Product Change Notification

1. ECR #: 162158
Notification #: 318

3. Series:
• MMCX7 - 75 OHM JACK AND PLUG

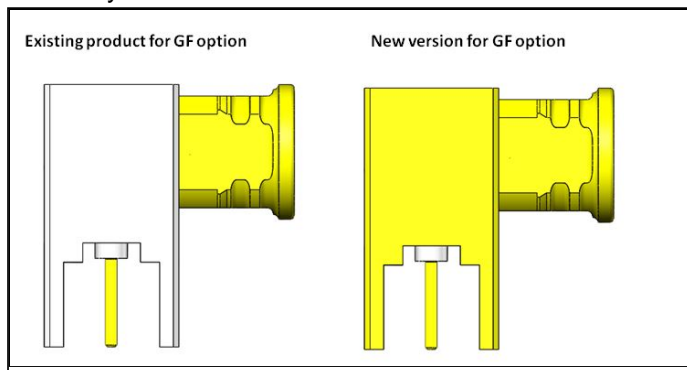
5. Description of Change:
The plating on the body will change from 100u" Nickel to 3u" flash Gold.

7. Reason for Change:
The shell and body is being changed from a two -piece design to a one-piece design to improve product robustness.

8. Impact of Change on Form, Fit, or Function:
• Form - For GF plating option, the plating on the body will change from Nickel to flash Gold.
